Your ref: 2016/5780/P

Planning application 2016/5780/P relating to The Old Dairy 2 Falkland Place London NW5 2PT

4 Falkland Place and The Old Dairy, 2 Falkland Place London, NWS – Daylight and Sunlight Matters

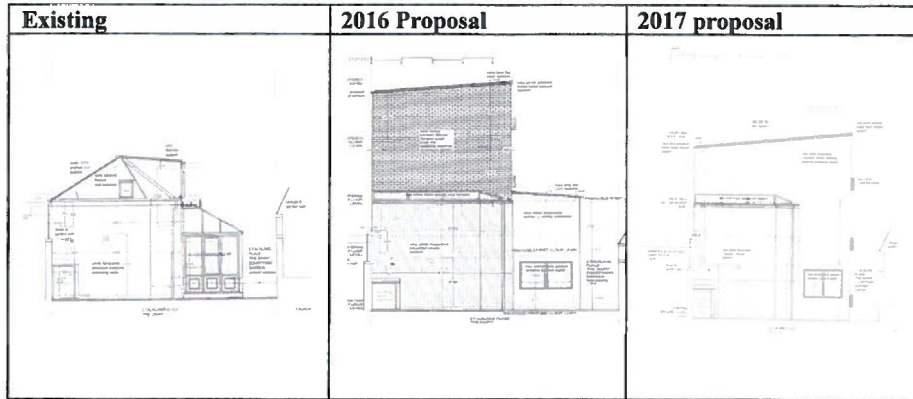
We can illustrate the difference as far as we are concerned by comparing the south elevation (facing our house) as it is now, as it was originally proposed, and as it is now proposed:

We are very surprised that it is possible for our neighbours to make such a big change in their proposed development without having to make a new planning application.

The new plans are even worse than the original plans. Although the height is a little lower, the massing and sense of enclosure created by the new proposed building will be much greater.
